Oriel

Response to Technical Queries on Cycle Provision

Oriel Planning

(Application Ref: 2020/4825/P)

Figure 02: Bicycle store layout by 'cycle-works'

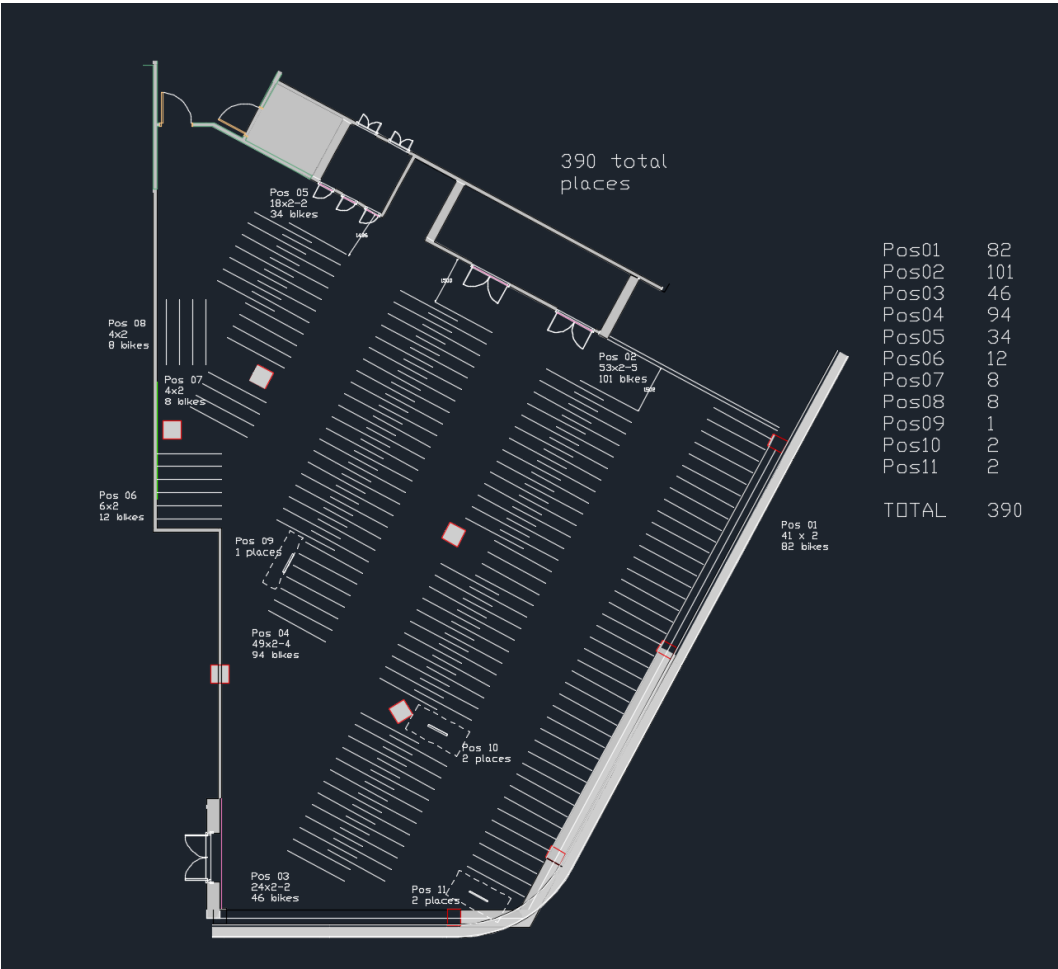
The cycle store layout submitted as part of the Planning application (16th October 2020) was developed in conjunction with 'cycle-works', the UK's exclusive distributor of the Josta 2-tier rack system, using the high-capacity racks. This rack type is custom made for specific sites and the recommended spacing is 2000mm min for optimal operation (loading/ off-loading from the top tier between rows of stands). The racks are set 300mm from adjoining walls or columns for handlebars and racks spaced at a minimum of 400mm centres for ease of use. A minimum of 2600mm clear headroom is required and the store ceiling height is 3900mm.

Figure 04: Lower Ground Floor Plan – updated bicycle store layout (P&P)

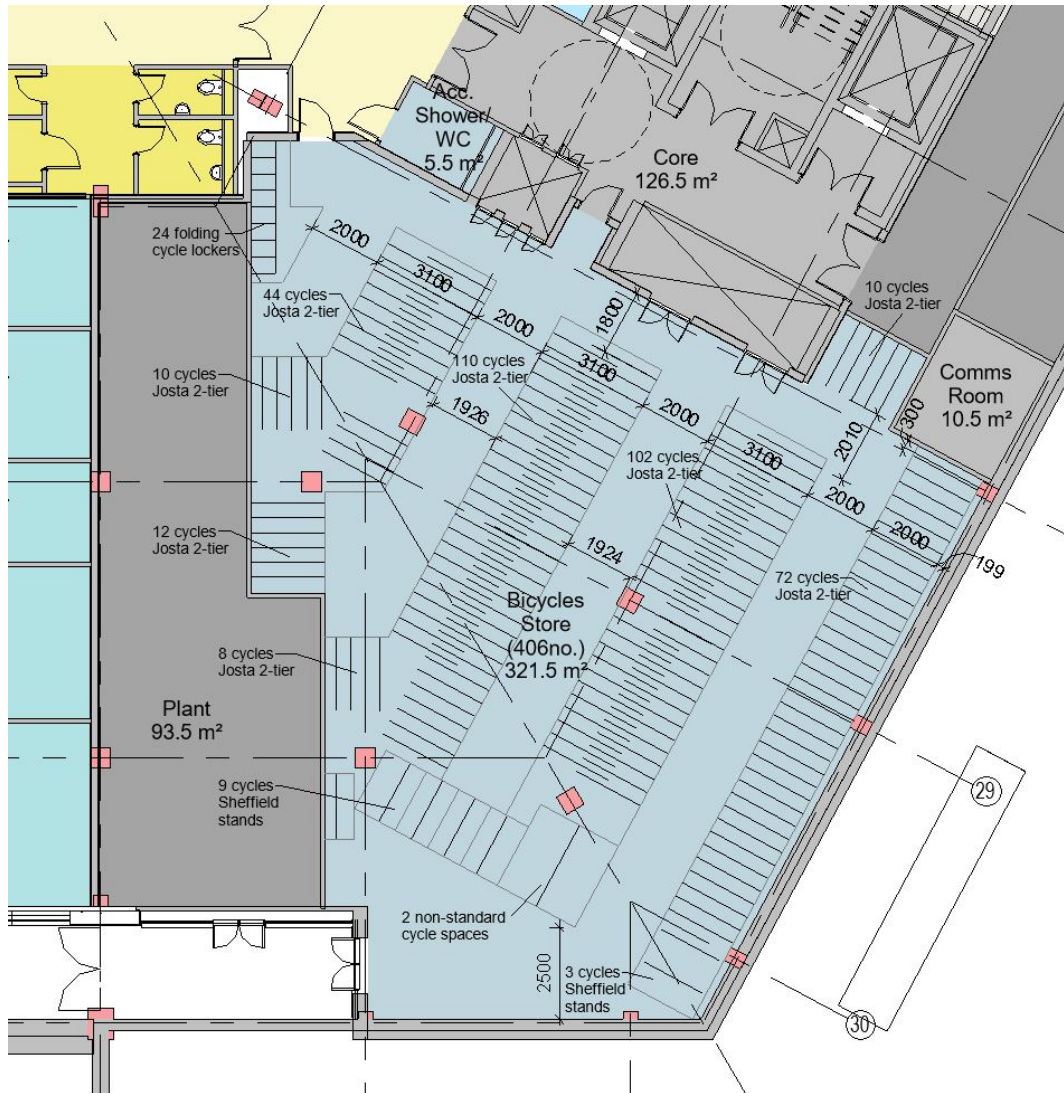
Following recent design development, we have adjusted the adjacent plant room, increased the area of the store, and amended the cycle layout to achieve the LB Camden long-stay spaces required.

The layout now includes 406no. secure cycle parking spaces, consisting of 368no. Josta 2-tier stands; 24no. folding cycle lockers; 12no. Sheffield stands and 2no. non-standard cycle bays. The Sheffield or CaMden M stands are positioned close to the cycle store entrance to accommodate the required circulation. This also reduces the distance for cyclist to travel off the bicycle within the store. The circulation space beyond the 2no. non-standard cycle spaces is 2000mm between the Josta 2-tier rows and 1800mm alongside the ends.

To achieve the maximum capacity of spaces, the access route between rows of double-stacked cycle stands is set out in the stand's specification at 2000mm. The access spines between the double stacked rows do not follow the Camden Planning Guidance – Transport (March 2019: para. 8.43 / January 2021: para. 8.44) as 2500mm clearance to access the top tier spaces significantly reduces the number of cycle parking spaces.
